Well Name: POLES PARADISE	Well Location: T30N / R14W / SEC 9 / SWSW / 36.82403 / -108.320196	County or Parish/State: SAN JUAN / NM
Well Number: 90	Type of Well: OTHER	Allottee or Tribe Name:
Lease Number: NMNM16057	Unit or CA Name:	Unit or CA Number:
US Well Number: 300453195700S1	Operator: DUGAN PRODUCTION CORPORATION

Type of Submission: Notice of Intent	Type of Action: Plug and Abandonment
Date Sundry Submitted: 10/27/2025	Time Sundry Submitted: 07:43
Date proposed operation will begin: 10/31/2025

CONDITIONS OF APPROVAL

Notice of Intent – Plug and Abandonment

Planned P & A Wellbore Schematic

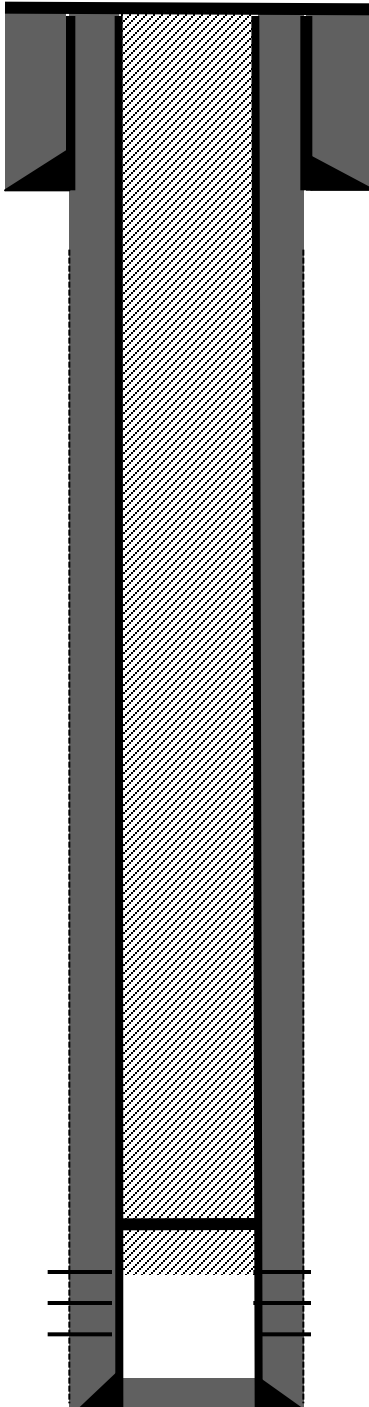
1. Plugging operations authorized are subject to the attached "General Requirements for Permanent Abandonment of Wells on Federal and Indian Lease."
2. The following modifications to your plugging program are to be made:
 - a. Complete well bore fill up proposal. No changes to the procedure.
3. **Notification:** Farmington Office is to be notified at least 24 hours before the plugging operations commence at (505) 564 7750.

Complete wellbore fill up proposal. No changes to the procedure.

You are also required to place cement excesses per 4.2 and 4.4 of the attached General Requirements.
